BULLETIN

CB24-E-001A

IMPORTANT SAFETY RECALL

F-SERIES TIE-ROD INSPECT & REPLACE – 24V-467

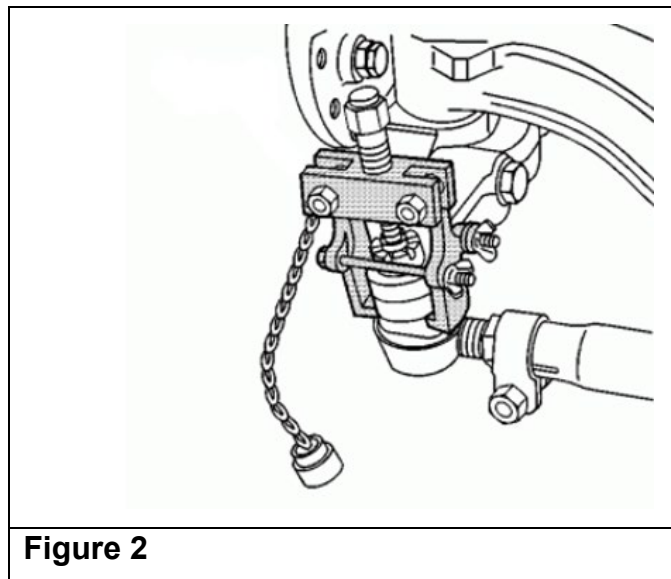
10. Remove the nut (Item no.1 in Figure 1) from the driver side tie-rod end.
11. Using a pitman arm puller or similar tool, remove the tie rod from the driver's side steering knuckle. (See Figure 2.)

12. Turn the front passenger wheel to the left.
13. Remove and discard the cotter pin (Item no. 2 in Figure 1) from the passenger side tie rod end.
14. Remove the nut (Item no.1 in Figure 1) from the passenger side tie-rod end.
15. Using a pitman arm puller or similar instrument, remove the tie rod from the passenger's side steering knuckle. (See Figure 2.)

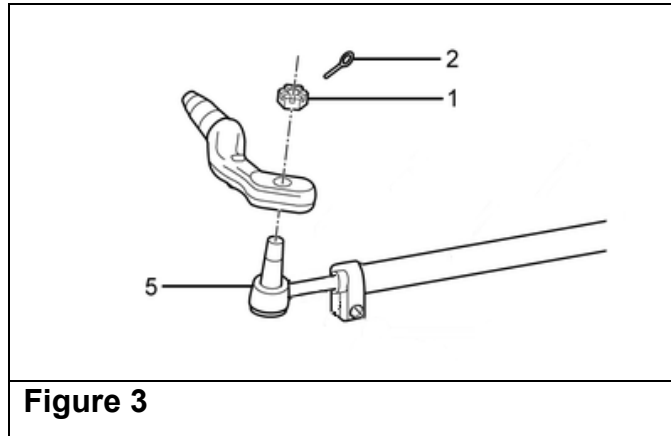
18. Adjust each end of the NEW tie-rod assembly so the same number of threads are visible as counted on the old tie-rod assembly in Step 7.
19. Install the tie rod assembly onto the passenger side steering knuckle and install the tie rod nut (Item no.1 in Figure 3) hand tight.

20. Torque the passenger side tie rod nut (Item no.1 in Figure 3).

21. Install a new cotter pin (Item no. 2 in Figure 3) on the passenger side tie-rod end.

23. Install the tie rod assembly onto the driver's side steering knuckle and install the tie rod nut (Item no. 1 in Figure 3) hand tight.

25. Install a new cotter pin (Item no. 2 in Figure 3) on the driver's side tie-rod end.
